**BRADD**

No. 026  
February 12, 2010

**Work Point Coordinates for Superstructures With  
Integral Abutments and Beam Offsets for  
Adjacent Box Beams**

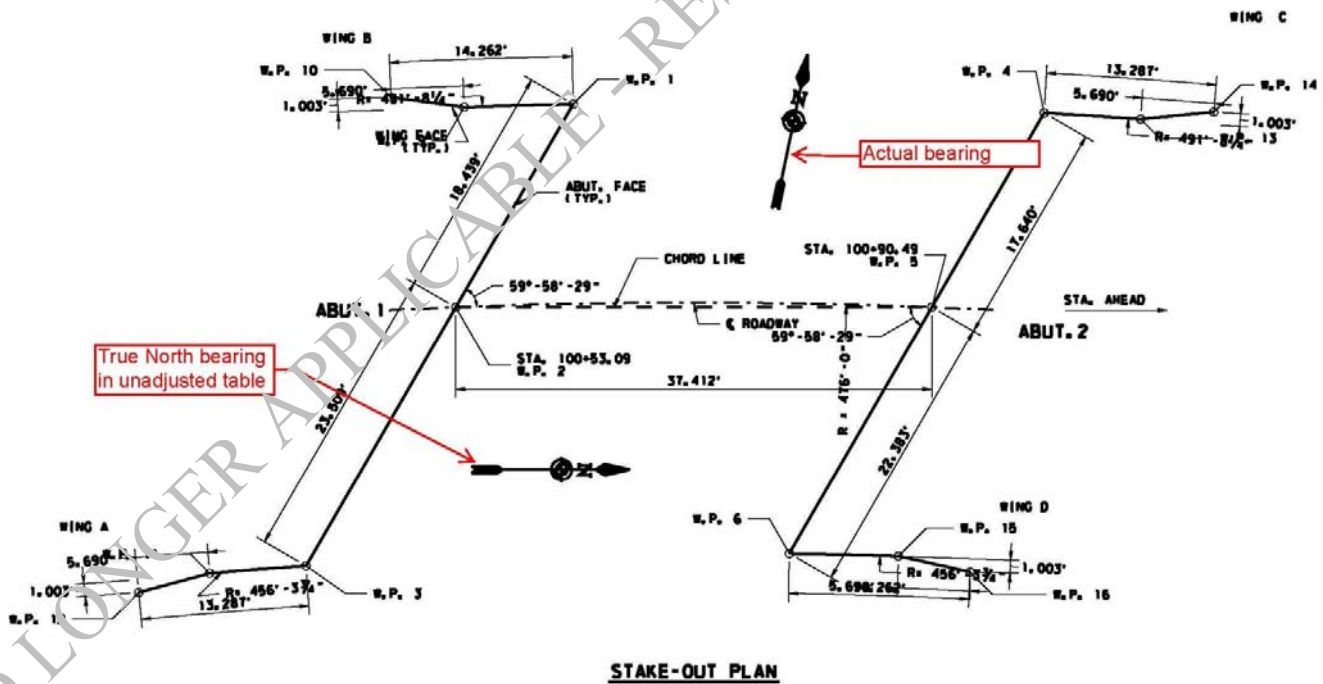
The work point coordinates for superstructures with integral abutments that appear on the stake out plan drawings were not being rotated to the bearing of the back tangent reference line. The station and offset workpoint values were correct.

All Coordinate values are suspect

The workaround for this problem is to manually rotate the workpoints shown on the table by the angle of the back tangent reference relative to true North, following the procedure in the BRADD Users Manual, section 3.2.4.2.

A fix for this problem is available in BRADD version 3.1.4.1. This version can be downloaded as a patch from the BRADD website.

The following partial Framing Plan detail shows the dimension referencing the centerline of beam 1 that was corrected by this patch.

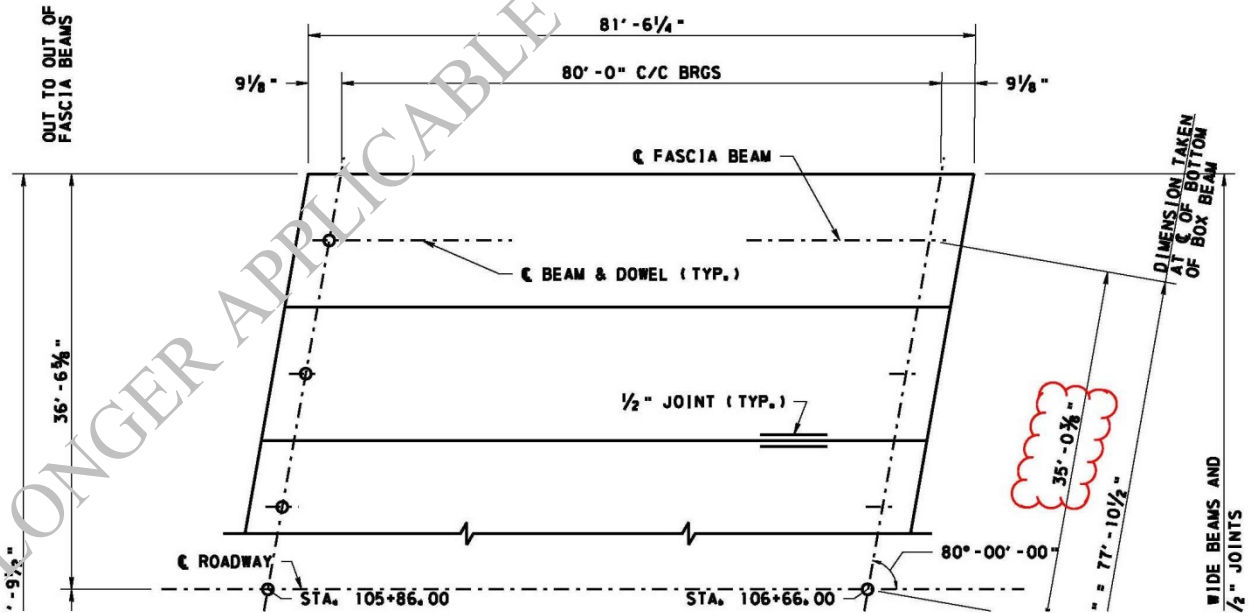
The beam offset dimensions were being calculated incorrectly on the left side of the deck for adjacent box beam superstructures with positive beam slopes (as specified in Section 7.2.3.6 of the BRADD Users Manual). A positive slope indicates that, looking ahead stations, the beam section has rotated clockwise, as shown in the cross-section below.

1. A mismatch between the offset value along the left side of the deck in the FRAMING PLAN detail and the Centerline Beam Offset value in the Abutment Bearing Seat Location And Elevation Table details. The values shown in the Abutment Bearing Seat Location And Elevation Table are correct.
2. This problem also affected the values shown in the Beam Offsets tables in the geometry output file, "Geometry.O1".
3. Also affected are the dimensions locating the centerline of beams in the Abutment Plan details.

There is no workaround, except to calculate the beam offsets manually and update the left beam offset shown in Framing Plan detail and the dimensions referencing the centerline of beam 1 in the Abutment Plan detail.

A fix for this problem is available in BRADD version 3.1.4.1. This version can be downloaded as a patch from the BRADD website.
